# Access Compliance Report

## Public Rights-of-Way

Intersection ID: 27451	Main Street: PROVIDENCE_RD	Cross Street: ALLISON_WOODS_DR	Location: NE
ADA ID: 095A4D90CCD7	Ramp Type: Perp	Initial Pass/Fail: Fail	Overall Compliance: No
Severity Score: 21.25			
Codes/Mitigation Info/Possible Solution		Field Measurements/Component Compliance

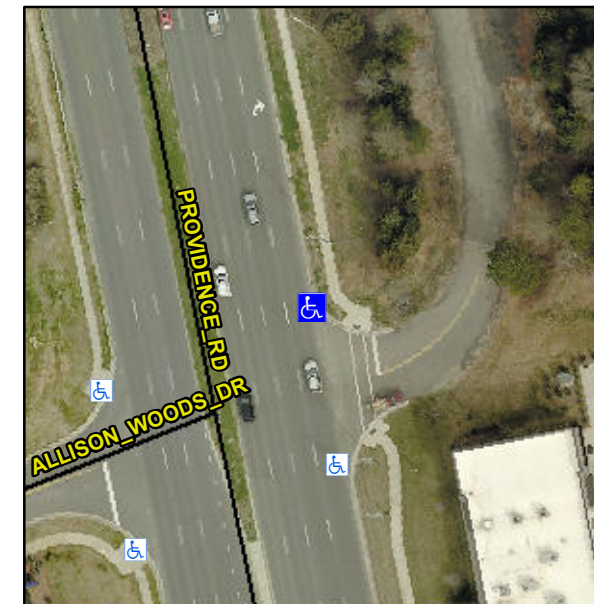
**Not Found, R304.5.1, R304.2.2**

Compliance	Description	Data	Compliance	Description	Data
N/A	Ramp Length (in)	78.0	No	Ramp Slope (%)	8.4
No	Ramp Width (in)	47.5	Yes	Ramp XSlope (%)	0.2
N/A	Flare Type LT	N/A	N/A	Flare Type RT	N/A
N/A	Flare Slope LT (%)	N/A	N/A	Flare Slope RT (%)	N/A
N/A	Flare Traversable LT?	N/A	N/A	Flare Traversable RT?	N/A
N/A	Landing Length (in)	N/A	N/A	DWS Provided?	N/A
N/A	Landing Width (in)	N/A	N/A	DWS Contrast?	N/A
N/A	Landing Slope (%)	N/A	N/A	DWS Length (in)	N/A
N/A	Landing X Slope (%)	N/A	N/A	DWS Full Width?	N/A
N/A	Landing Curb? (Y/N)	N/A	N/A	DWS Offset (in)	N/A
N/A	Shared Landing?	N/A			
N/A	Gutter Ponding?	N/A	N/A	Gutter Slope (%)	N/A
N/A	Gutter Lip Ht (in)	N/A	N/A	Gutter X Slope (%)	N/A
N/A	Painted X Walk1?	Yes	N/A	Painted X Walk2?	N/A
	X Walk 1 Direction	To S		X Walk 2 Direction	N/A
N/A	X Walk 1 Width (in)	74.0	N/A	X Walk 2 Width (in)	N/A
	X Walk 1 Slope (%)	1.7		X Walk 2 Slope (%)	N/A
	X Walk 1 X Slope (%)	1.4		X Walk 2 X Slope (%)	N/A

**Remove & Replace Entire Ramp.**
